**ANN ARBOR WASTEWATER TREATMENT PLANT  
FACILITIES RENOVATIONS**

**ITB No. 4191**

**ADDENDUM NO. 2  
DECEMBER 12, 2011**

ISSUED STATUS: BID SET  
DATE: NOVEMBER 2011  
SHEET: M05-19  
CAD REF. NO. 3185004\_118

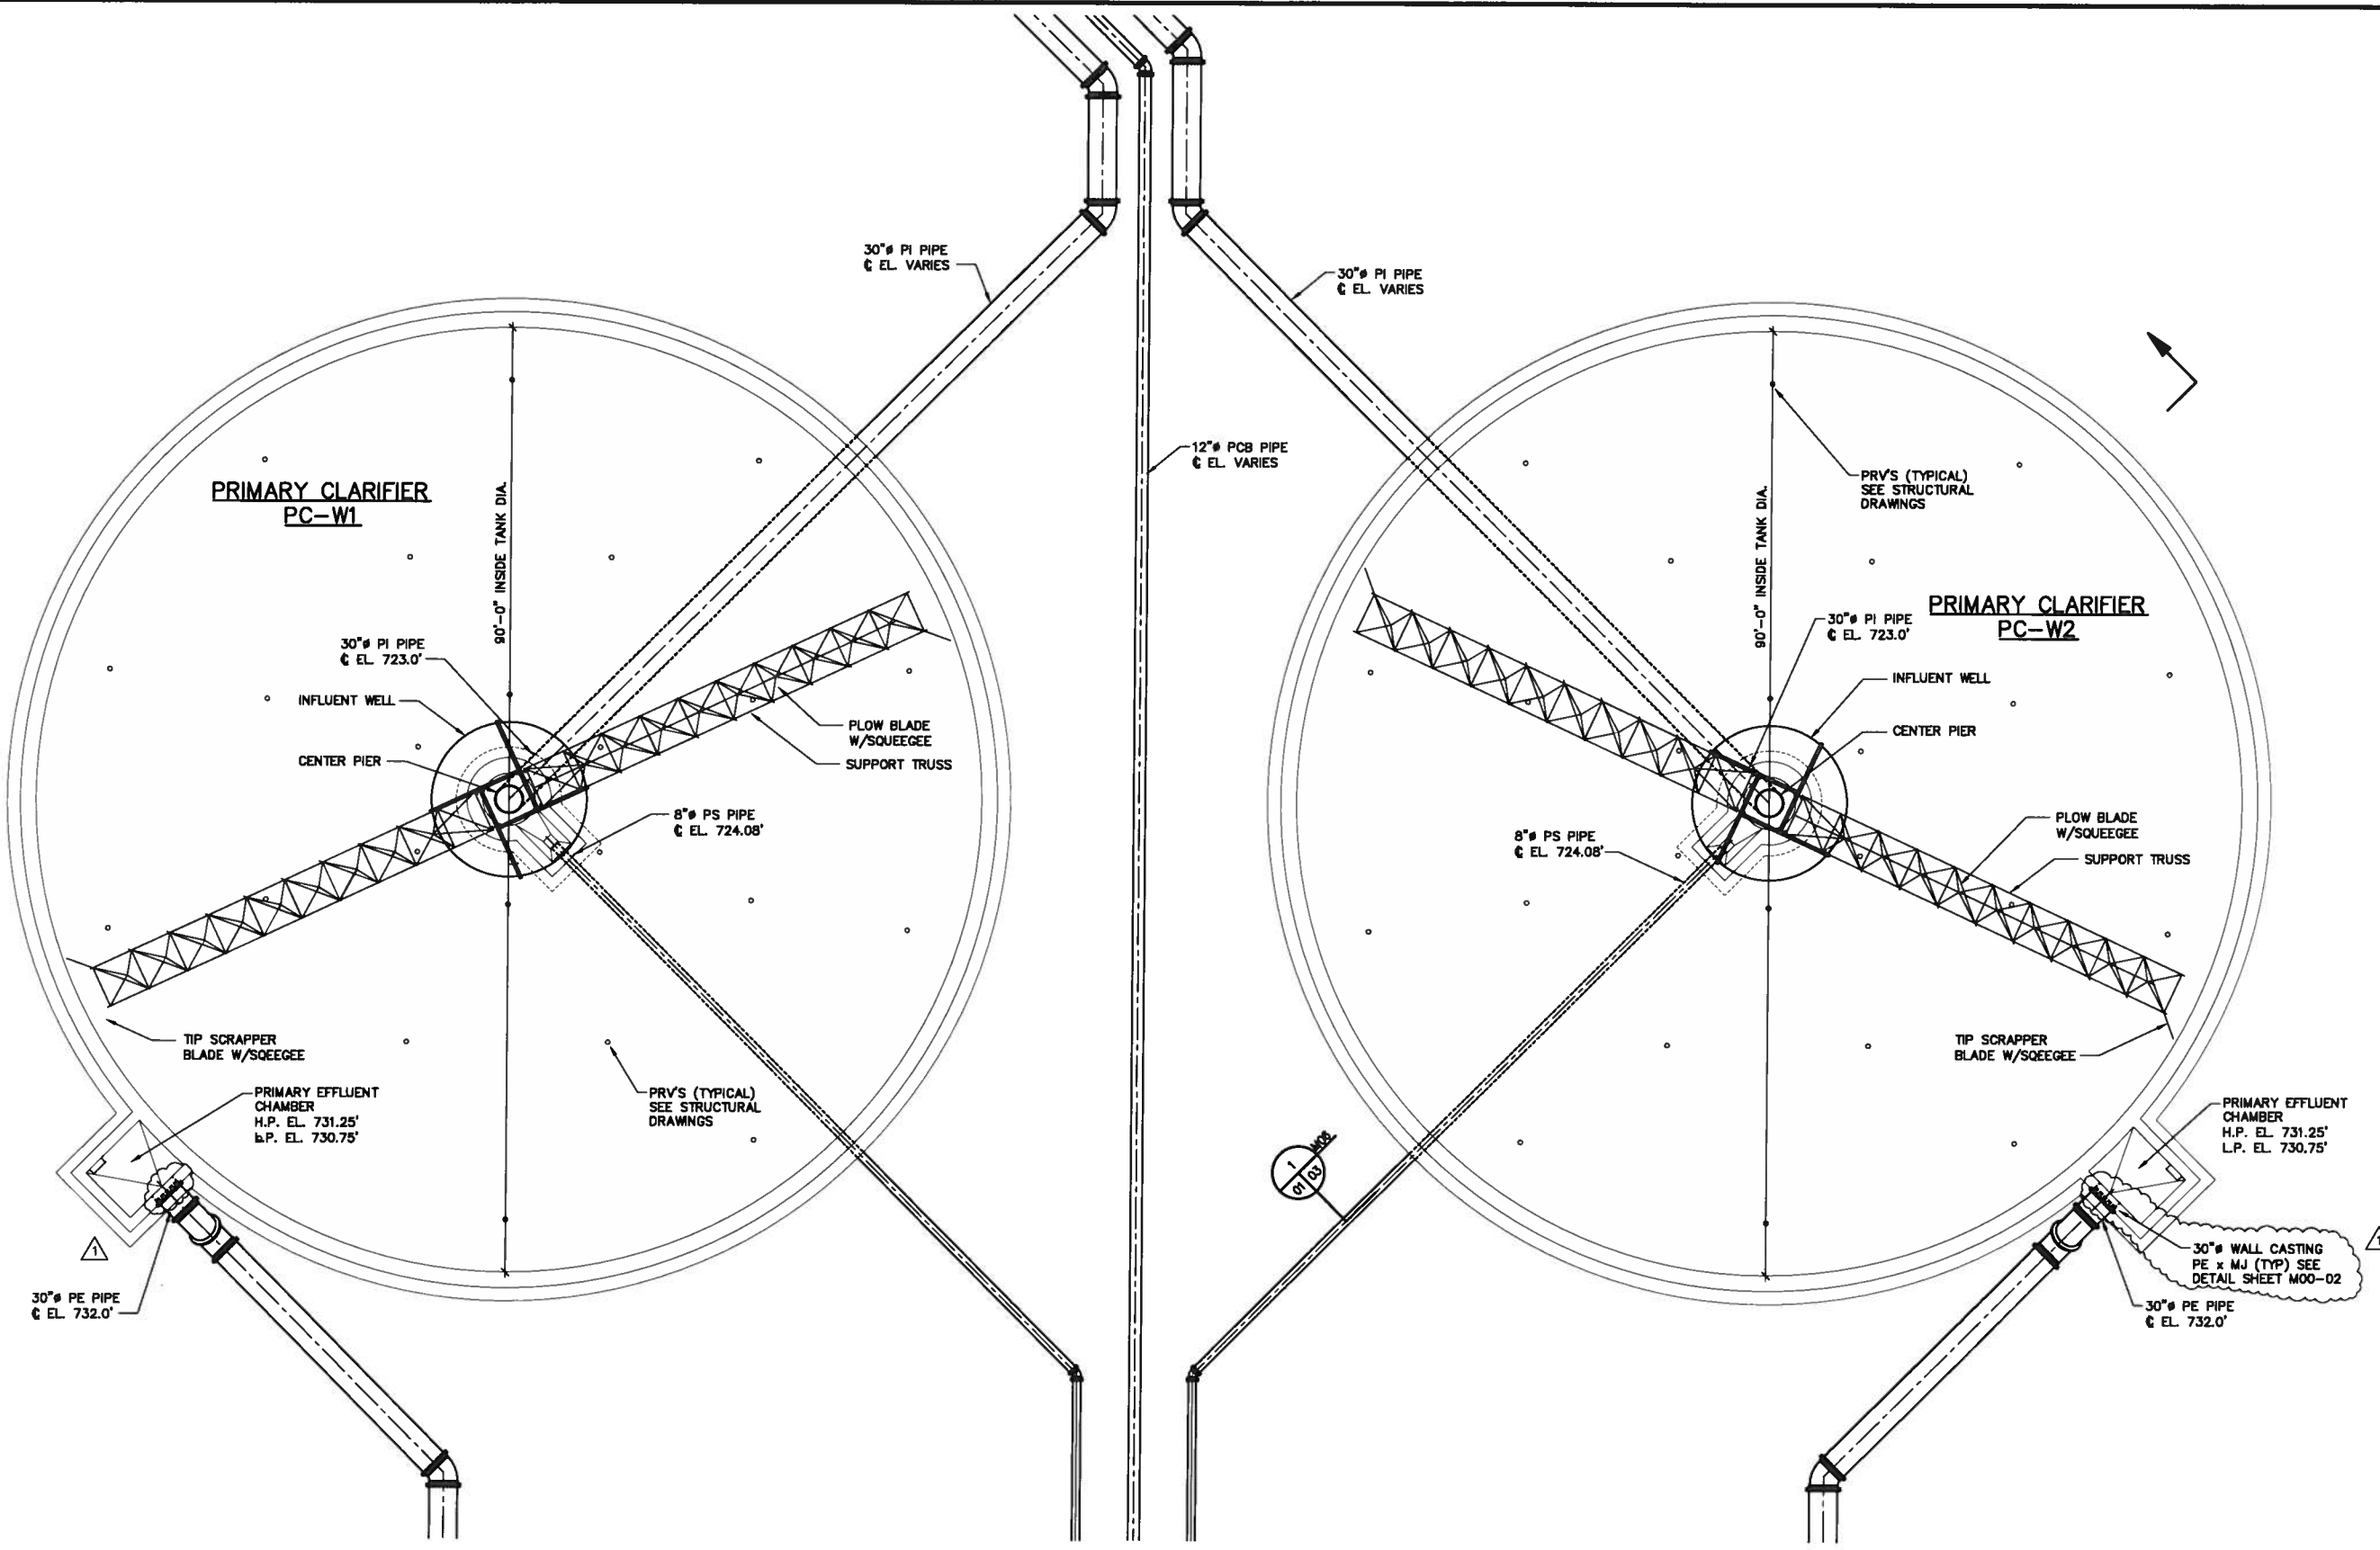
**Bidder's Question: 5** - On sheet M05-19 there is a 6" line at the top of the page drawn darker than the rest. I am assuming that this is the 6" SAM discharge line. Although it is drawn with flange joints. According to Table 15052-A the 6" SAM line is to be PVC. Am I correct that the 6" SAM line is to be PVC?

**Response:** *The 6" SAM line shall be Ductile Iron. See Project Manual Volume VI of VI, Page 15052-23 revisions in Addendum No. 2.*

ISSUED STATUS: BID SET  
DATE: NOVEMBER 2011  
SHEET: M06-01  
CAD REF. NO. 3185004\_103

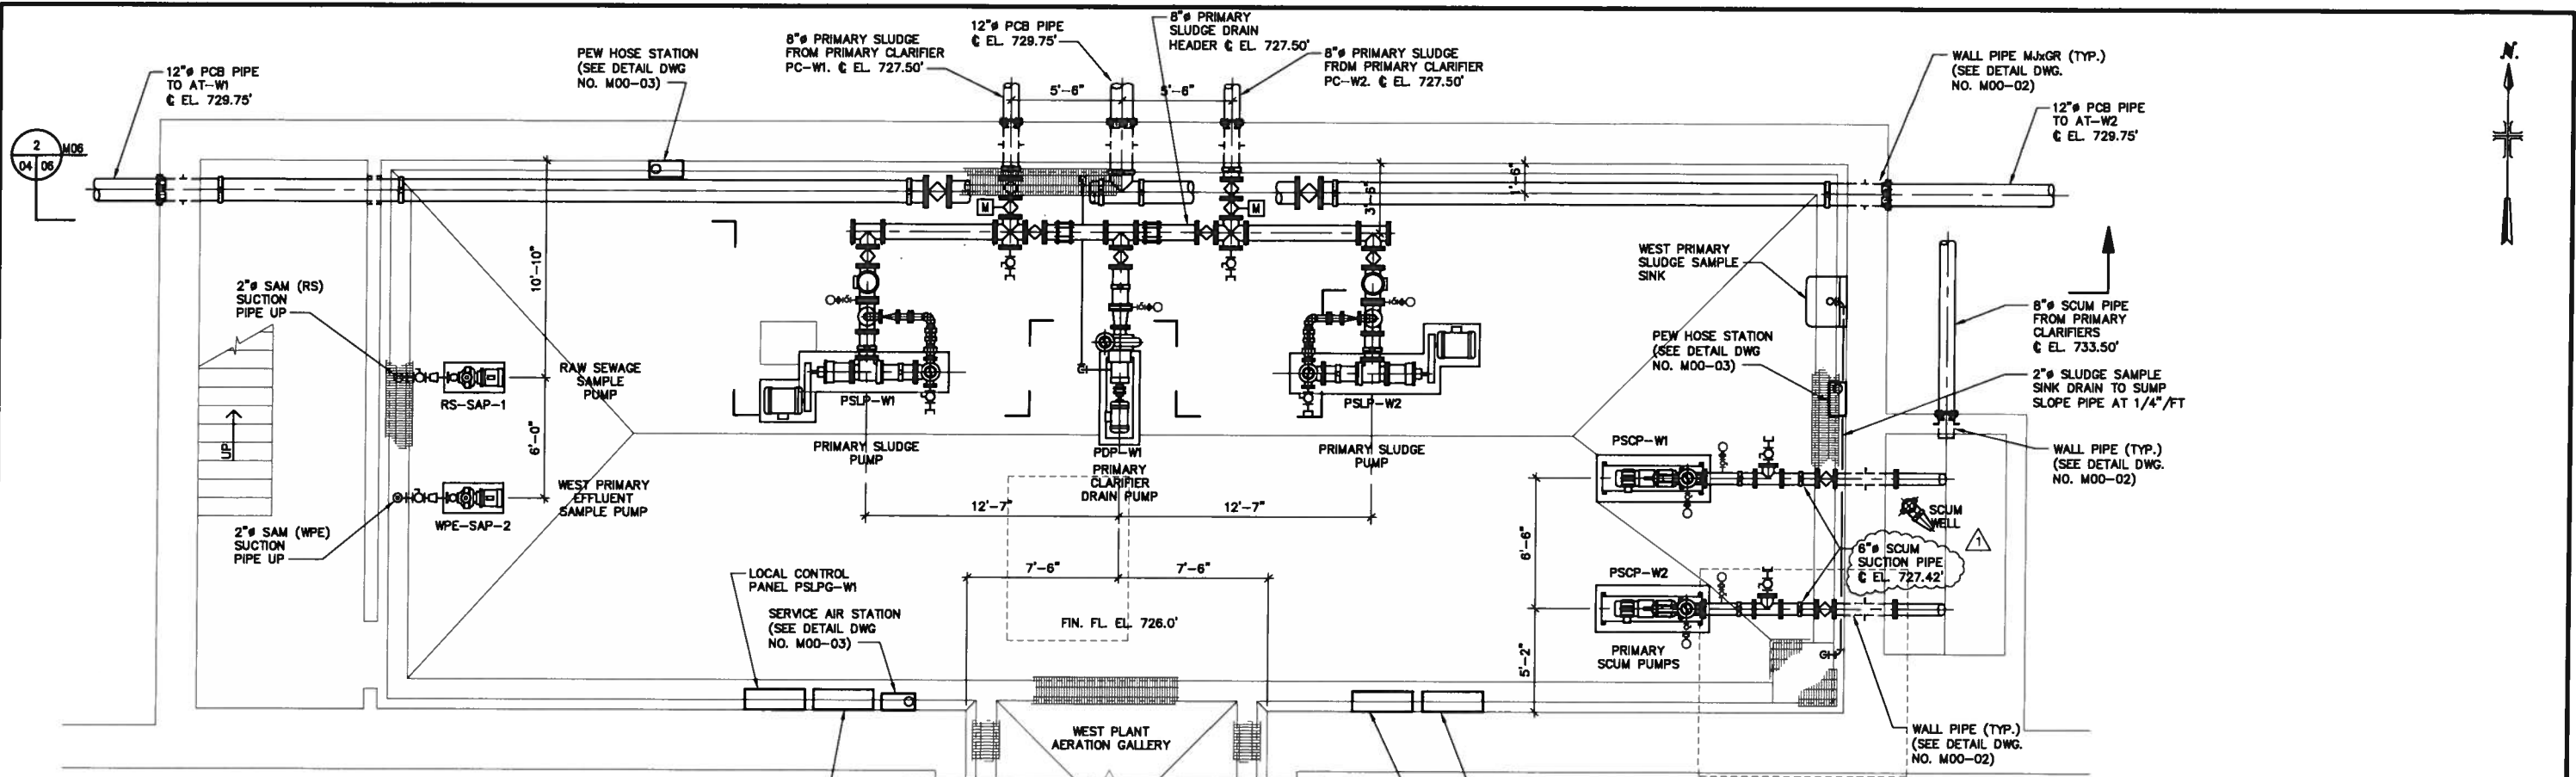
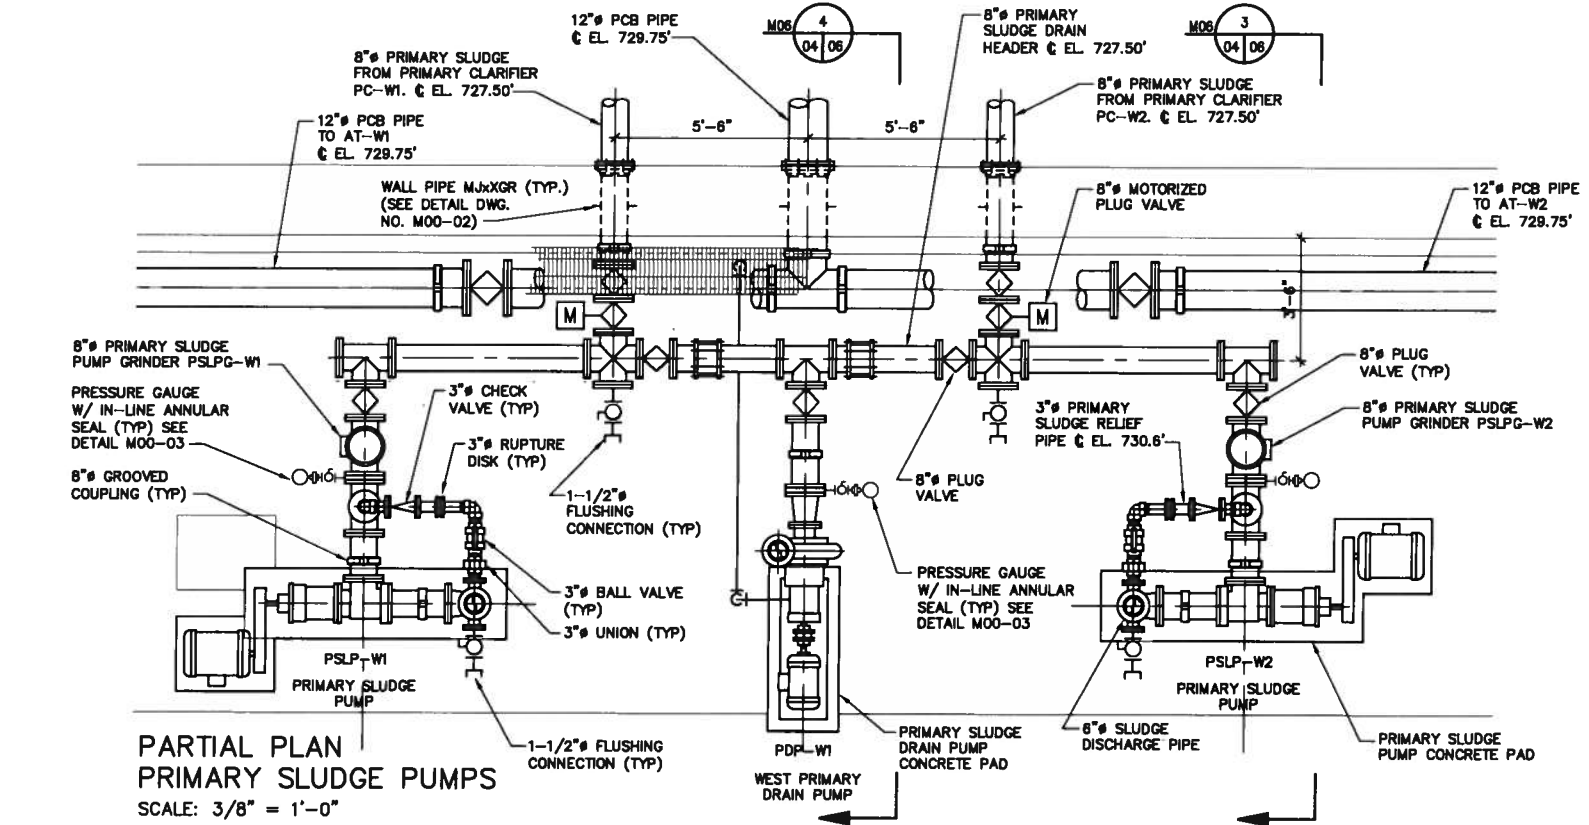
**Bidder's Question:** On sheet M06-01 the 30" PE pipe into the Primary Effluent Chamber, is the intent a wall sleeve with seals or a plain end x collar x plain end wall pipe?

Do the lines beneath the West Primary Clarifiers (8" PS & 30" PI) and the lines beneath the West Secondary Clarifiers (42" ML & 12" RAS) need to be restrained?

*Response: The 30" PE pipe through the Primary Effluent Chamber shall be Wall pipe, Plain end x collar x mechanical joint. See Contract Drawing No. M06-01 revisions in Addendum No. 2.*

*Response: Yes, the lines beneath the West Primary Clarifiers and the lines beneath the West Secondary Clarifiers shall be restrained.*

ISSUED STATUS: BID SET  
DATE: NOVEMBER 2011  
SHEET: M06-04  
CAD REF. NO. 3185004\_135

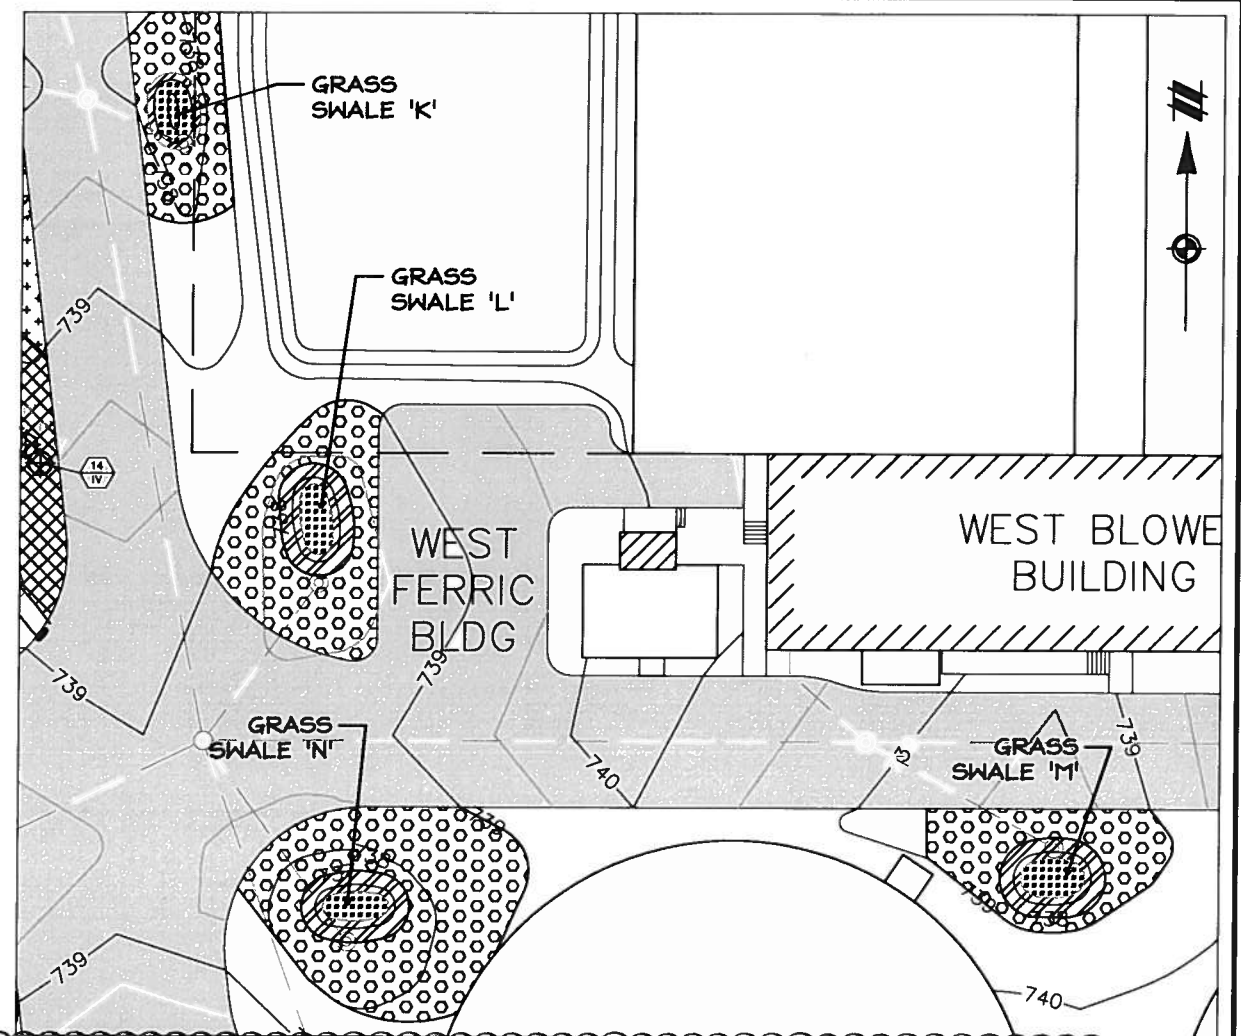
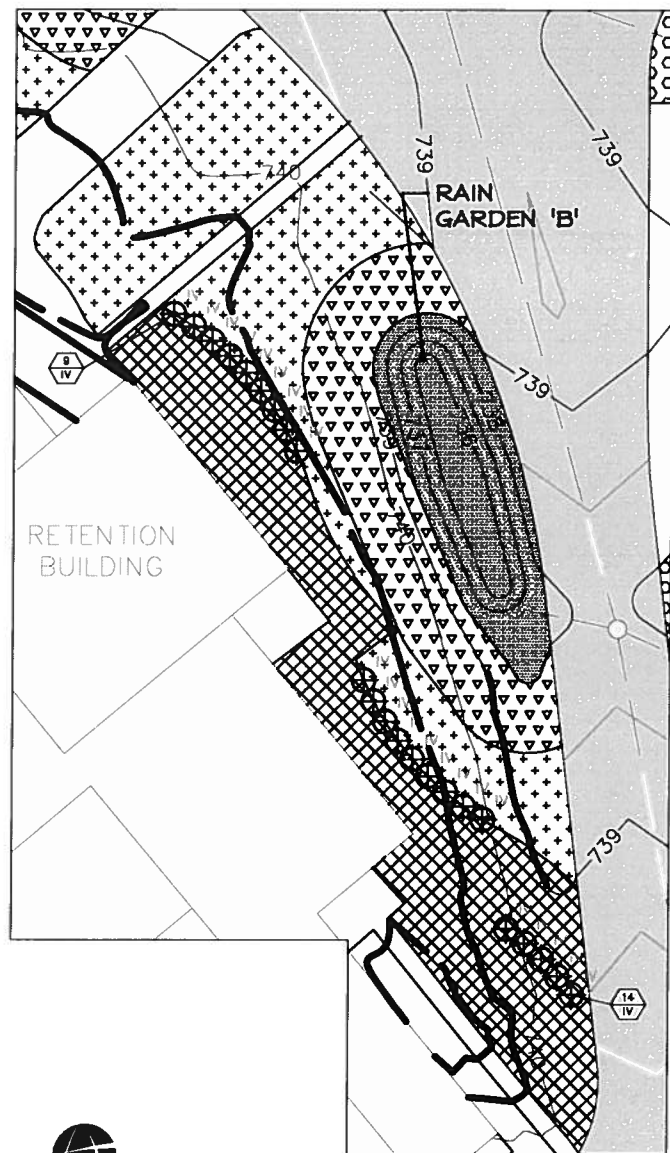
**Bidder's Question:** On sheets M06-04 & -06 is the 6" scum suction pipe from scum well to primary scum pumps 6" or 8"?

**Response:** *The scum suction pipe shall be 6". See Contract Drawing No. M06-04 revisions in Addendum No. 2.*

ISSUED STATUS: BID SET  
DATE: NOVEMBER 2011  
SHEET: C01-27  
CAD REF. NO. \_\_\_\_\_

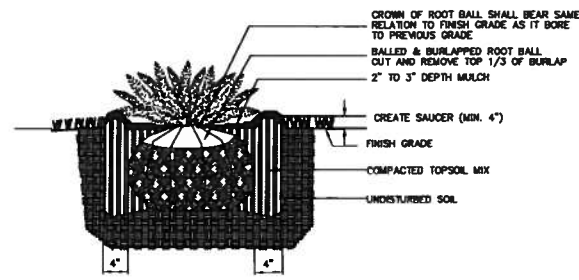
**Bidder's Question:** Sheets C01-27 & 31

What are the quantities of plugs for various planting zones (C, D, E, F) and rain gardens (A, B, D, D). There only appear to be total quantities, but not individual species shown on the Plant Schedules.

*Response: See revised Sheets C01-27 and C01-31 attached to this Addendum..*
